ECE/TRANS/WP.29/GRSP/2007/6  
21 February 2007

REGULATION No. 95  
(Lateral collision)

Proposal for draft corrigendum to Regulation No. 95

Submitted by the expert from Japan

Fig. 1 Neck Flexion Test Velocity – Time curve ( Filter : CFC180 )

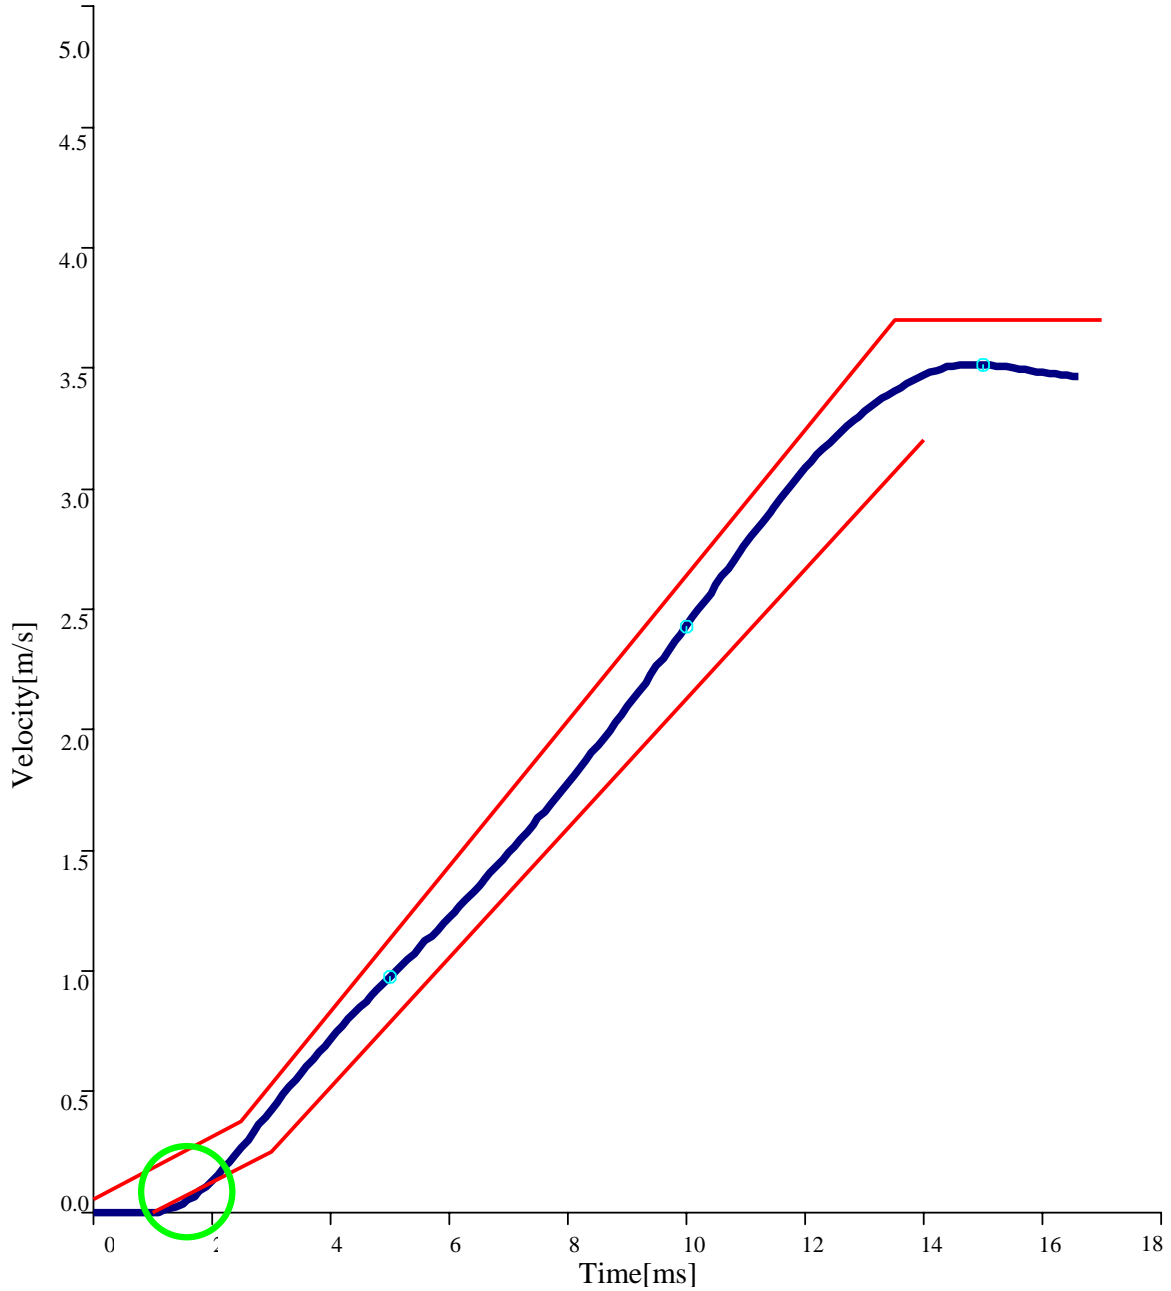
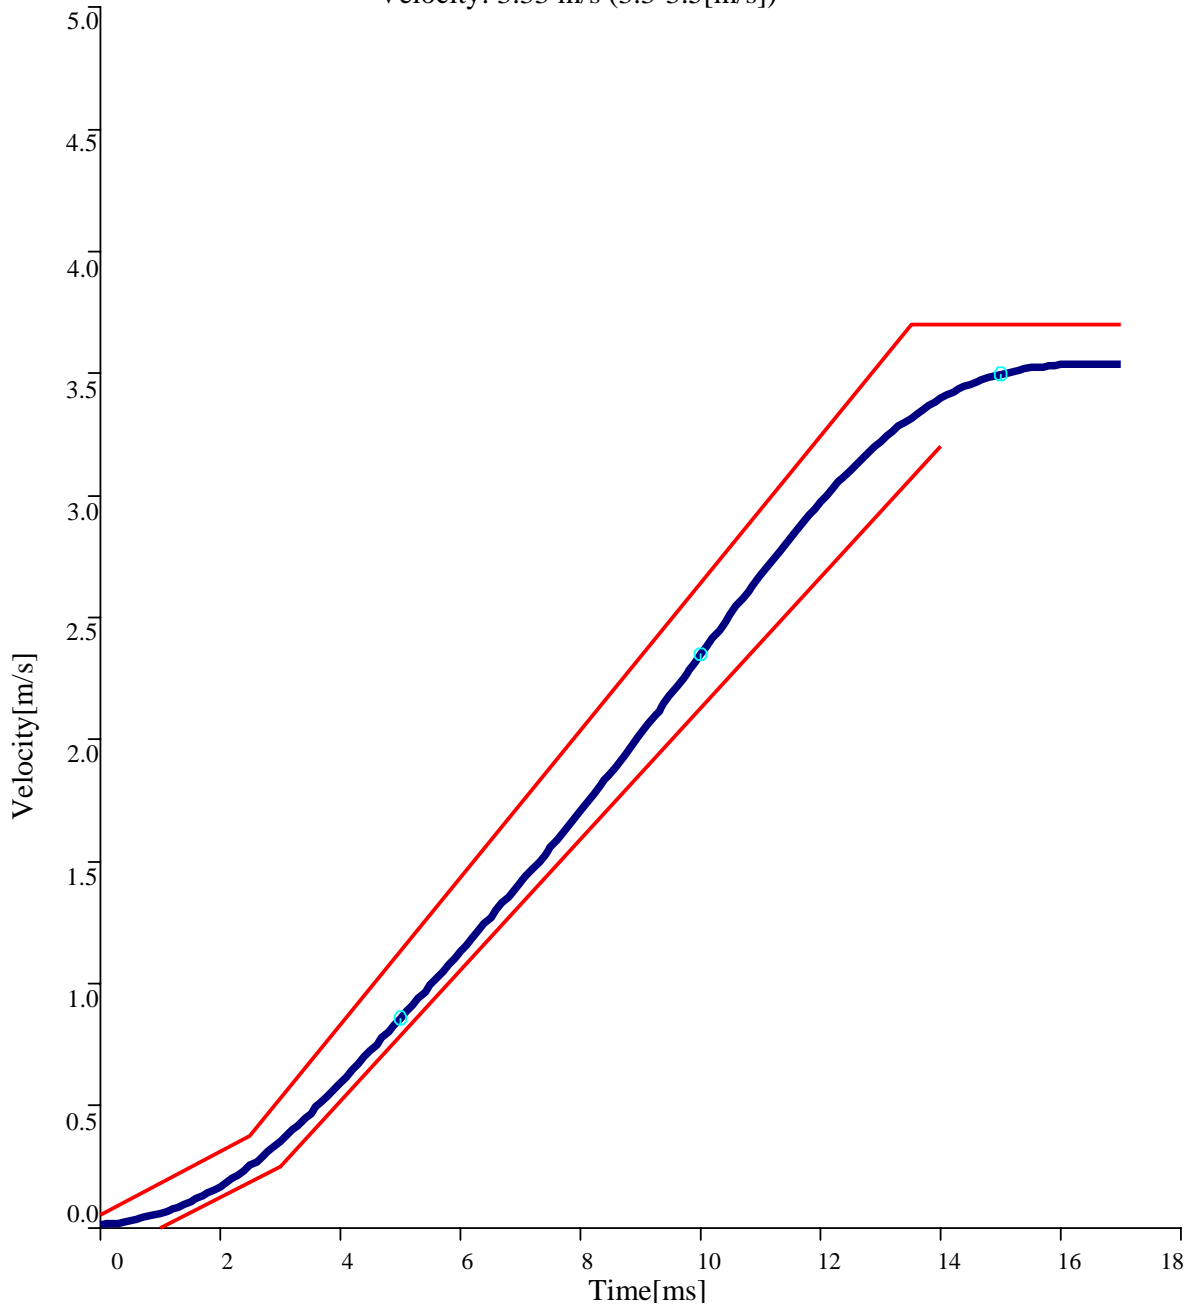
The filters that are fitting the specifications of ISO 6487:2000 CFC 180 cannot satisfy the respective velocity change – time corridors (for the neck in Figure 7 and for the lumbar spine in Figure 8 of the Regulation).

Figures 1 and 2 show the results of the same neck certification test using different filters (Figure 1 using CFC 180 and Figure 2 fitting CFC 60). As shown inside, the lower circle of Figure 1, the filter fitting CFC 180 does not completely satisfy the specified corridor.

"5.6.5. The neck-pendulum is decelerated from impact velocity to zero by an appropriate device 3/, as described in the neck pendulum specification (see Figure 5), resulting in a velocity change - time history inside the corridor specified in Figure 7 and Table 4 of this Annex. All channels have to be recorded according to the ISO 6487:2000 or SAE J211 (March 1995) data channel recording specification and filtered digitally using ISO 6487:2000 CFC 180 or **SAE J211:1995 CFC 180. The pendulum deceleration has to be filtered using ISO 6487:2000 CFC 60 or SAE J211:1995 CFC 60.**"

Fig. 3 Lumbar Flexion Test Velocity – Time curve (Filter : CFC180)

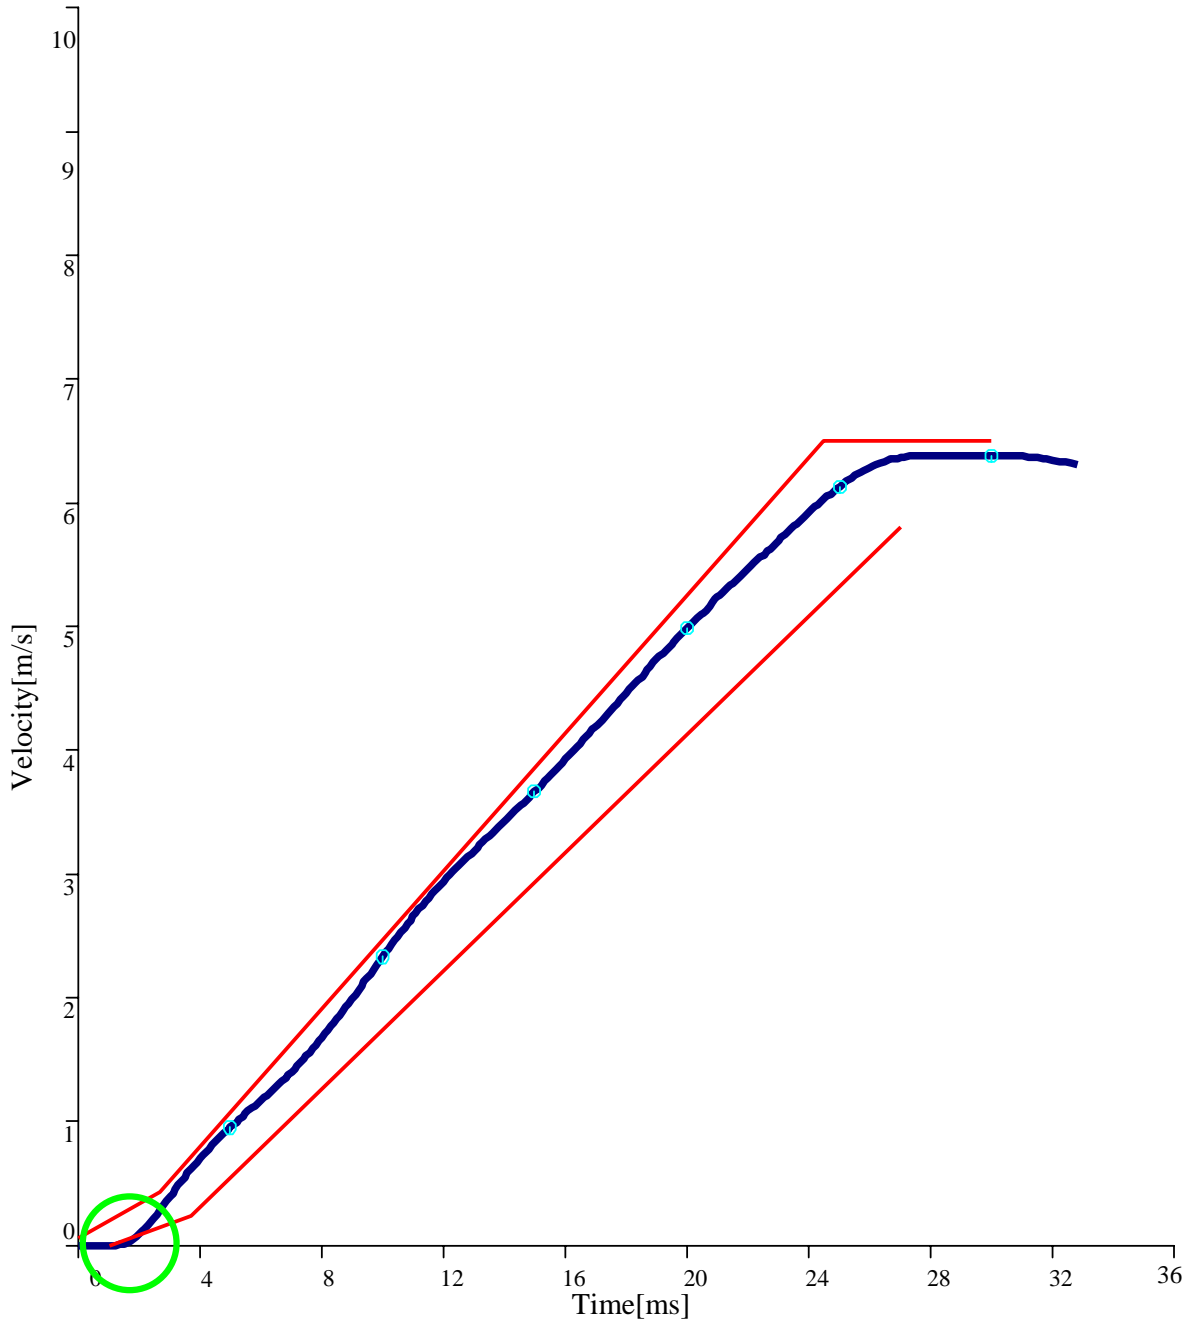
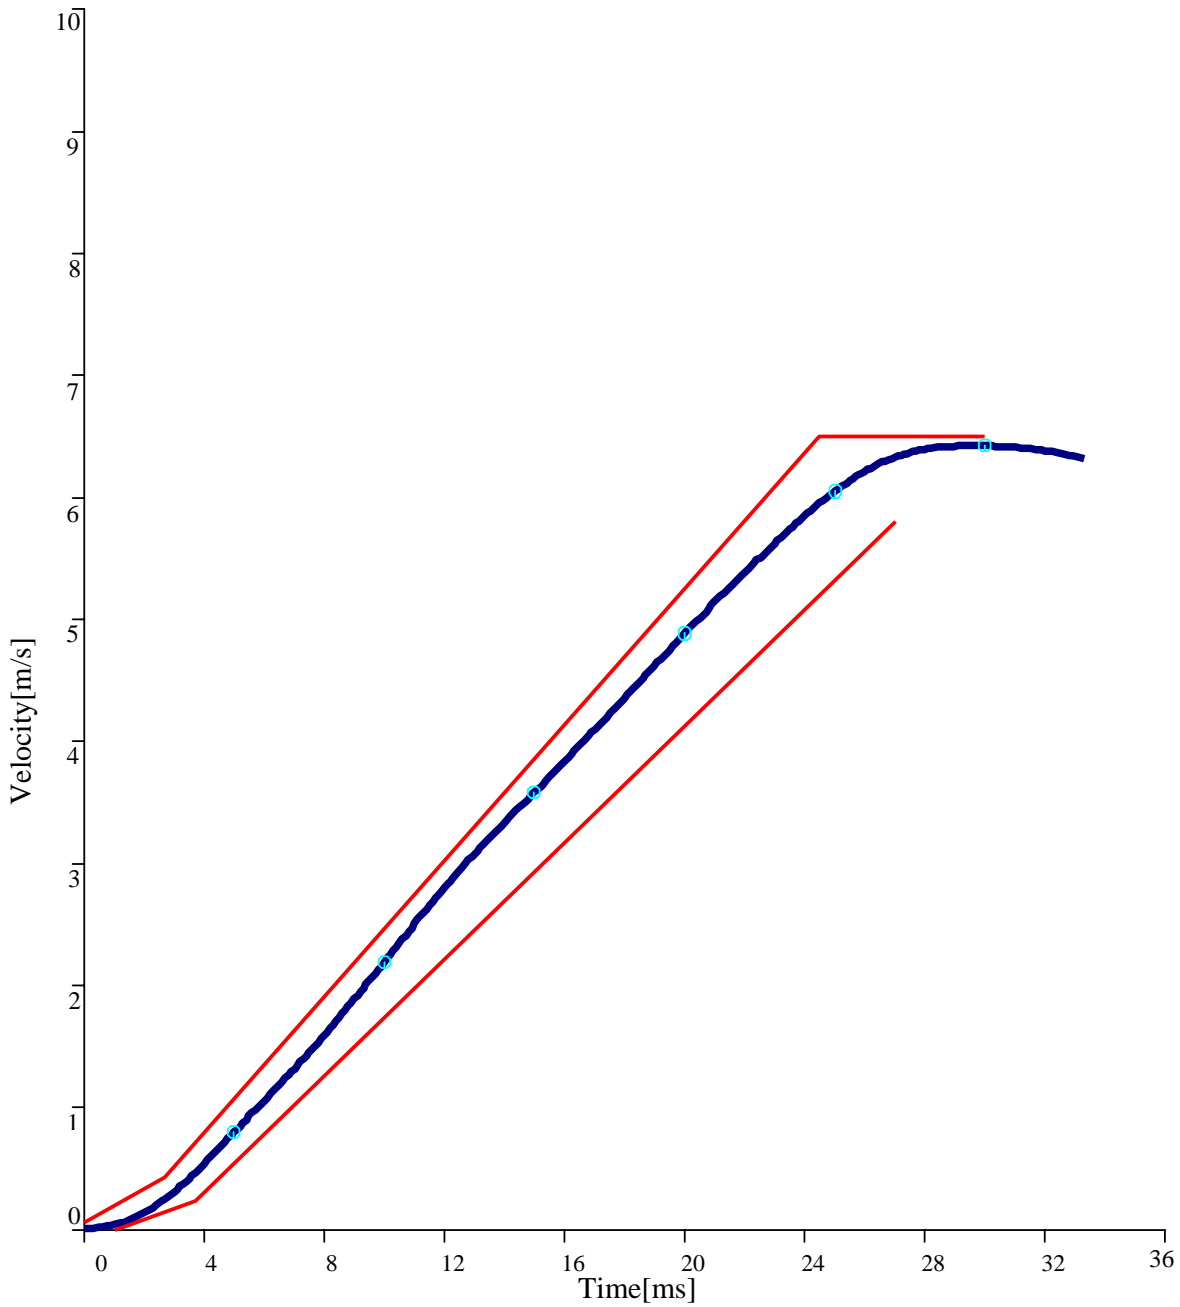
Similarly, Figures 3 and 4, which show the results of the lumbar spine certification test, demonstrate that the filter fitting CFC 180 does not completely satisfy the specified corridor (inside the lower circle of Figure 3).

"5.10.5. The neck-pendulum is decelerated from impact velocity to zero by an appropriate device 6/, as described in the neck pendulum specification (see Figure 5), resulting in a velocity change - time history inside the corridor specified in Figure 8 and Table 6 of this Annex. All channels have to be recorded according to the ISO 6487:2000 or SAE J211 (March 1995) data channel recording specification and filtered digitally using ISO 6487:2000 CFC 180 or **SAE J211:1995 CFC 180. The pendulum deceleration has to be filtered using ISO 6487:2000 CFC 60 or SAE J211:1995 CFC 60.**"
